Access Compliance Report

Public Rights-of-Way

(Curb Ramps)

Intersection ID: 53713	Main Street: N_TRYON_ST	Cross Street: PERIWINKLE_HILL_AV	Location: NE
ADA ID: FA9E9152430D	Ramp Type: BlendTrans2	Initial Pass/Fail: Pass	Overall Compliance: No
Severity Score: 5			
Codes/Mitigation Info/Possible Solution		Field Measurements/Component Compliance

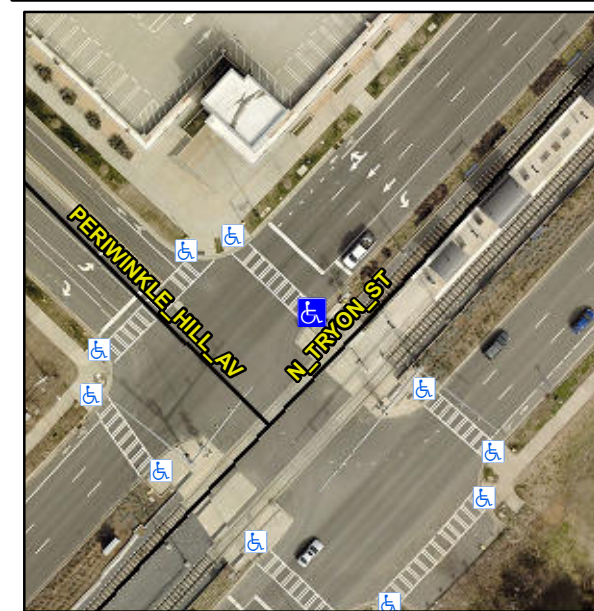
Remove & Replace Curbed Edge.

R304.2.3
